SUBJECT: MCPC #25-0150-002 - Waverly Heights

PROJECT:
TENTATIVE SKETCH PLANS
FOR
WAVERLY HEIGHTS
PROPOSED DEVELOPMENT
1400 WAVERLY ROAD GLADWYNE, PA 19035
LOWER MERION TOWNSHIP

Re: MCPC #25-0150-001
Plan Name: Waverly Heights
(36 dus on approximately 61.8 acres)
Situate: Waverly Road (north)/east of Youngs Ford Road
Lower Merion Township

**C-302**

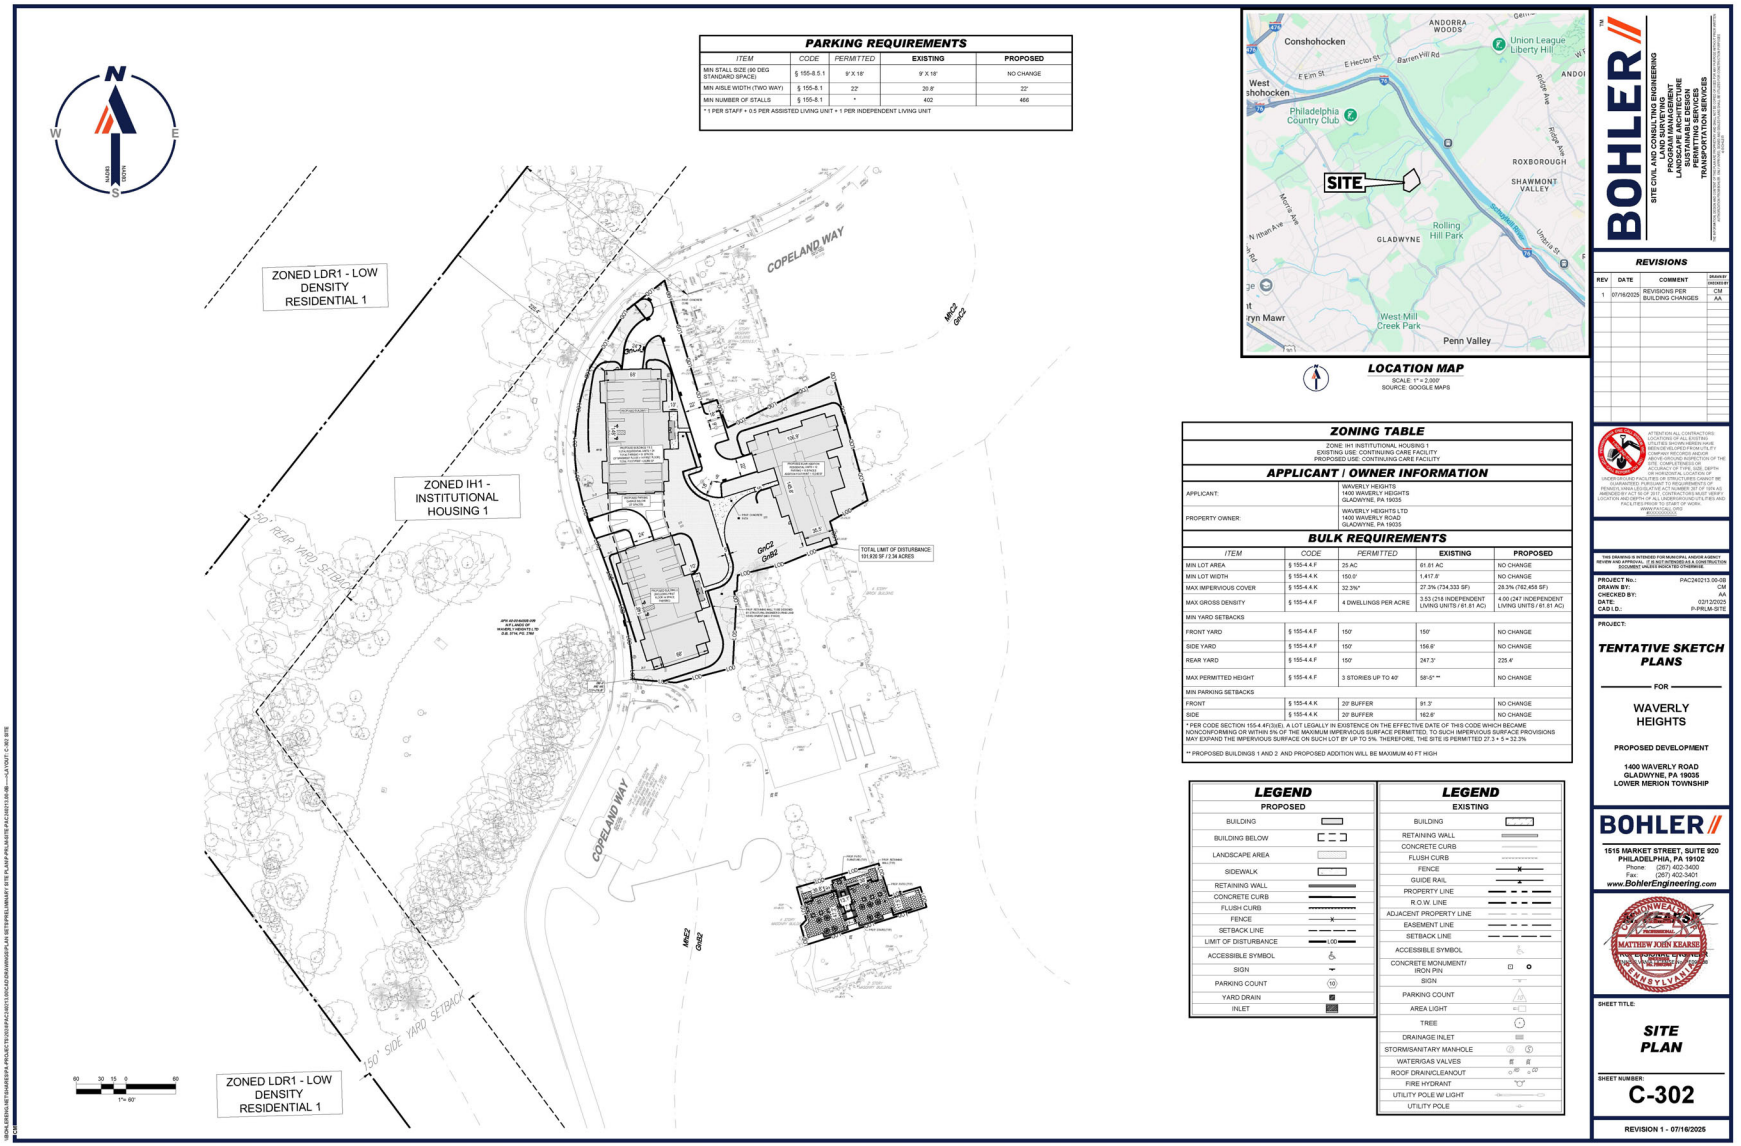
- §155-4.4.G.(6) states that "safe and convenient pedestrian and bicycle connectivity and access shall be provided, including a sidewalk or path along all frontages, unless alternative interior routes are approved." It appears that there is not a pedestrian connection between Proposed Building 1 and the rest of the proposed pedestrian pathways.

A. Maximum Grade of Driveways. Section 135-4.9.P.(8) establishes a maximum permitted grade for driveways. The proposed driveway to the Blair Apartment Building addition has a proposed slope in excess of 9% for much of its length. We defer to the township engineer regarding the feasibility of this driveway slope and compliance with §135-4.9.P.(8) depending on how the proposed use is classified.

Areas of steep grading are shown on the proposed grading and drainage plan. A slope in excess of 31% is proposed to the north of the Blair Apartment Building addition. This grading appears as if it may cause stormwater runoff to be directed towards the existing villa units to the north, therefore additional drainage improvements may need to be considered in this area.
